REMARKS

The Office Action mailed May 3, 2006 has been carefully considered. Reconsideration in view of the following remarks is respectfully requested.

In the Drawings

FIGURE 12B

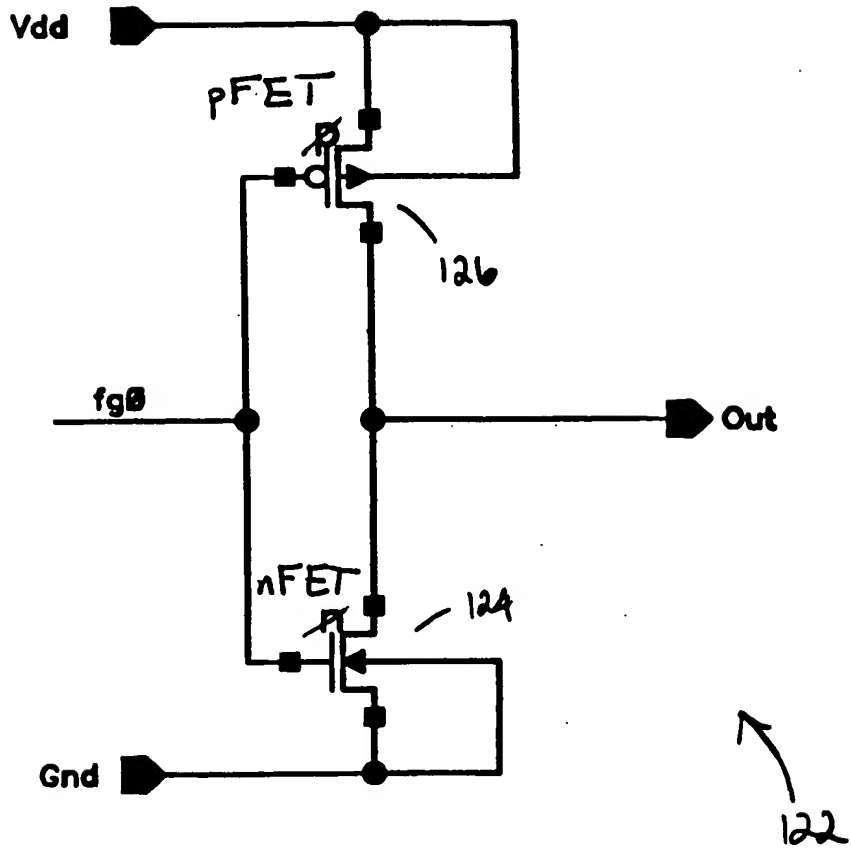
FIG. 12B has been amended to add the designations pFET and nFET.

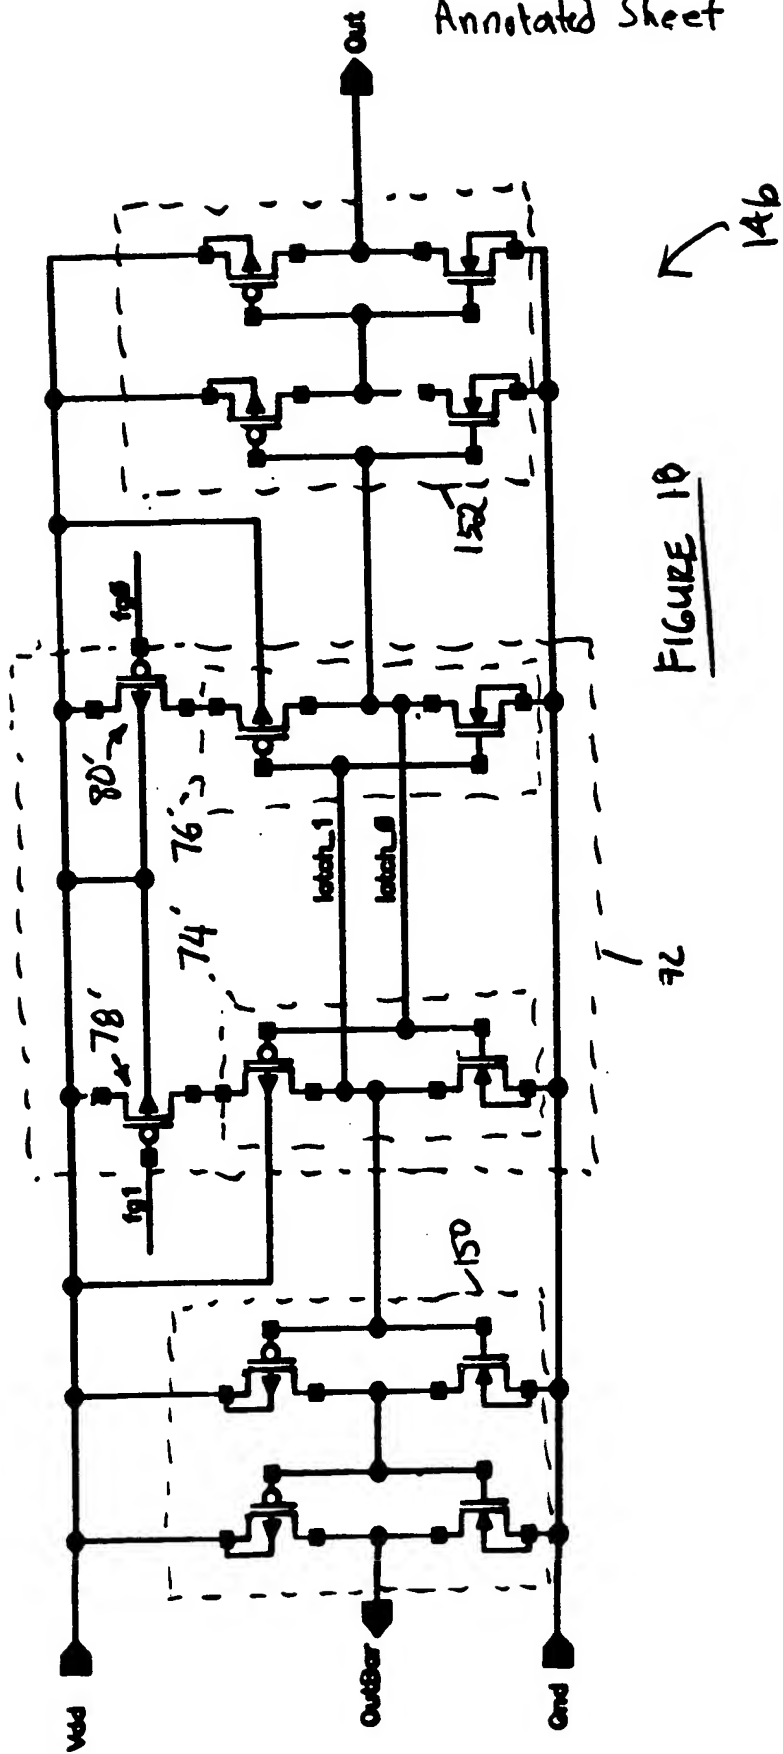
FIG. 18 has been amended to add the designations 74', 76', 78' and 80'.

FIGURE 19

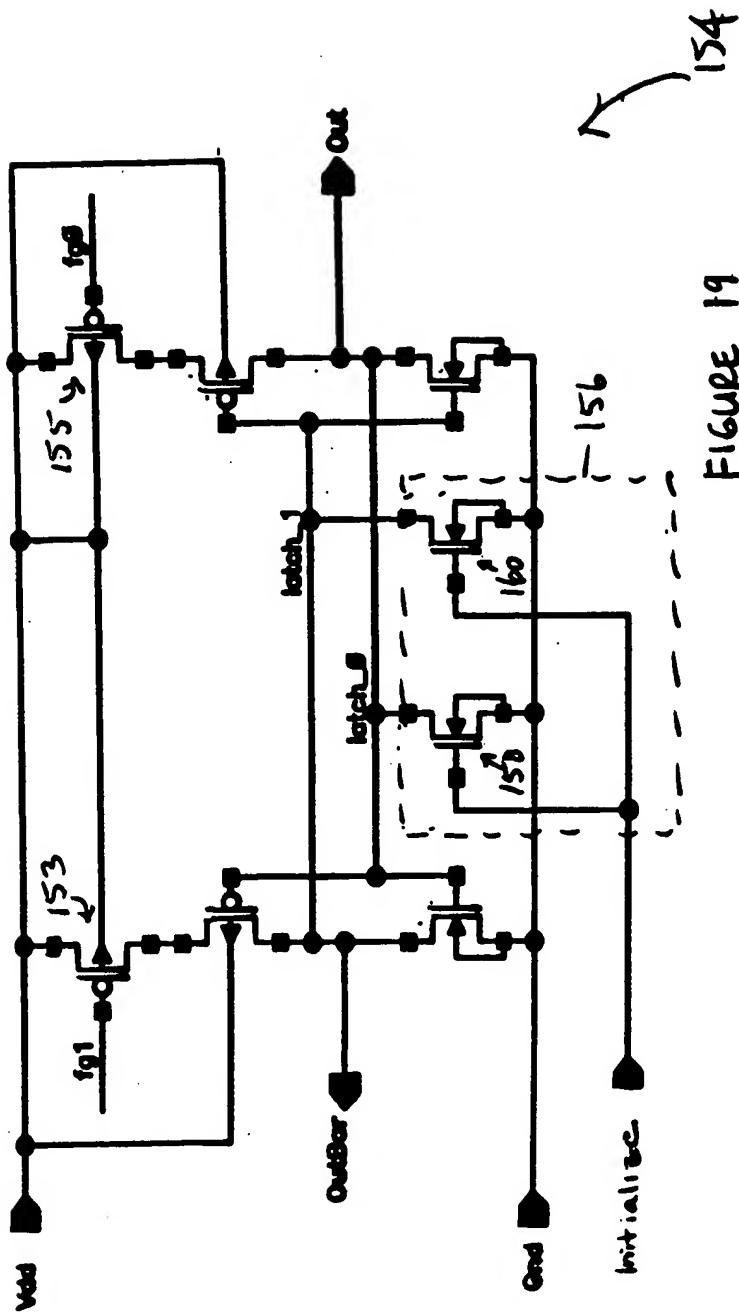
FIG. 19 has been amended to add the designations 153 and 155.
